Shadrick Creek Restoration Project

Annual Monitoring Report

Re: DMS Draft MY2 Monitoring Report
Review for the Shadrick Creek Restoration Project
Catawba River Basin – CU# 03050101
McDowell County, North Carolina
NCEEP Project # 92916
Contract No. 7343

I have outlined our responses to the comments on the Draft Monitoring Year 2 report for the Shadrick Creek Stream Restoration Site in (Red).

XS Number: 9
XS Type: Riffle

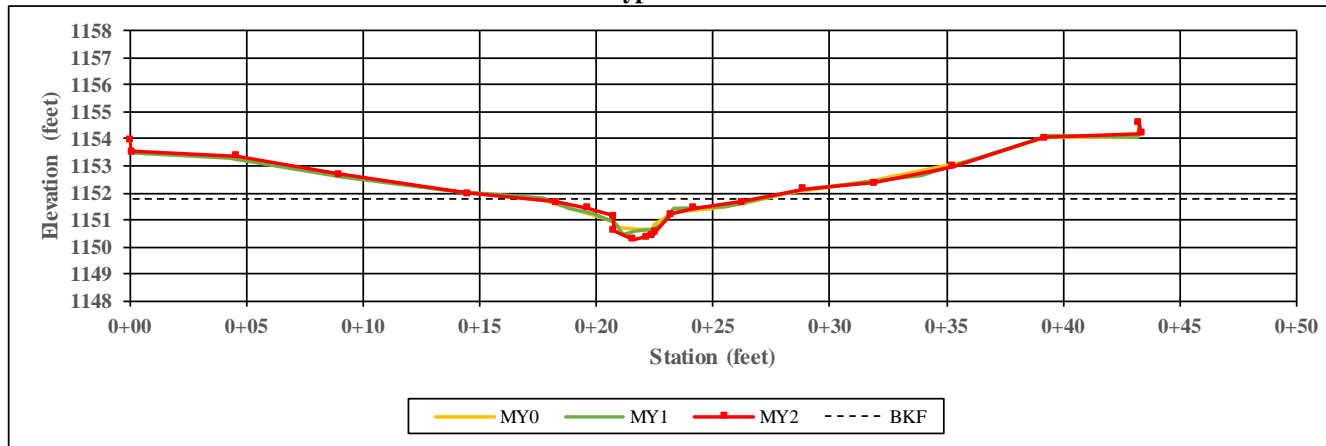
- XS9 - Seems to have enlarged between MY0 and MY2 but BHR decreasing. Believe it is due the choice of LTOB which is skewed to an elevation that is low relative to the selection process for LTOB at MY0. **Reviewed and Revised**
- XS17 - Decrease in BHR seem exaggerated based on overlays. Believe it is due the choice of LTOB which is skewed to an elevation that is low relative to the selection process for LTOB at MY0. **Reviewed and Revised**
- Please evaluate elevation selections for XS13 as well. **Reviewed and Revised**
